Access Compliance Report Public Rights-of-Way (Curb Ramps)

Intersection ID: 47642	Main Street: WESTON_WOODS_LN	Cross Street: KELLY_RD	Location: SE
ADA ID: 1D82047B7C92	Ramp Type: Perp	Initial Pass/Fail: Fail	Overall Compliance: No Severity Score: 33.75

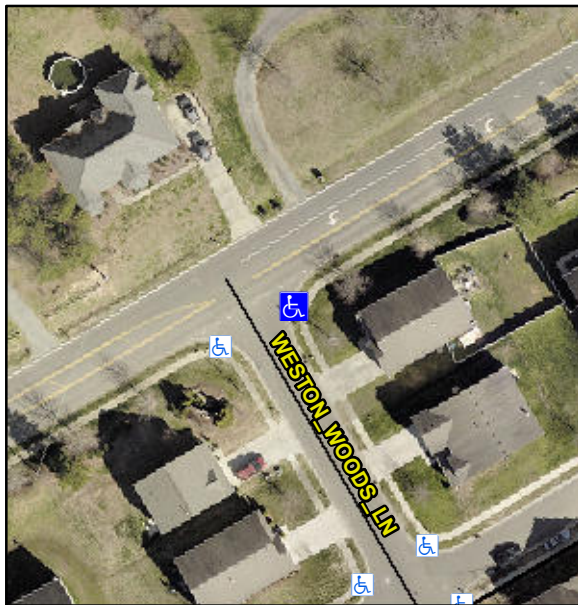
Not Found, R304.5.1, R304.5.3

Compliance	Description	Data	Compliance	Description	Data
N/A	Ramp Length (in)	99.0	Yes	Ramp Slope (%)	5.0
No	Ramp Width (in)	46.5	No	Ramp XSlope (%)	11.4
N/A	Flare Type LT	N/A	N/A	Flare Type RT	N/A
N/A	Flare Slope LT (%)	N/A	N/A	Flare Slope RT (%)	N/A
N/A	Flare Traversable LT?	N/A	N/A	Flare Traversable RT?	N/A
N/A	Landing Length (in)	N/A	N/A	DWS Provided?	N/A
N/A	Landing Width (in)	N/A	N/A	DWS Contrast?	N/A
N/A	Landing Slope (%)	N/A	N/A	DWS Length (in)	N/A
N/A	Landing X Slope (%)	N/A	N/A	DWS Full Width?	N/A
N/A	Landing Curb? (Y/N)	N/A	N/A	DWS Offset (in)	N/A
N/A	Shared Landing?	N/A			
N/A	Gutter Ponding?	N/A	N/A	Gutter Slope (%)	N/A
N/A	Gutter Lip Ht (in)	N/A	N/A	Gutter X Slope (%)	N/A
N/A	Painted X Walk1?	No	N/A	Painted X Walk2?	N/A
	X Walk 1 Direction	To SW		X Walk 2 Direction	N/A
N/A	X Walk 1 Width (in)	N/A	N/A	X Walk 2 Width (in)	N/A
	X Walk 1 Slope (%)	6.9		X Walk 2 Slope (%)	N/A
	X Walk 1 X Slope (%)	3.2		X Walk 2 X Slope (%)	N/A

Remove & Replace Entire Ramp.
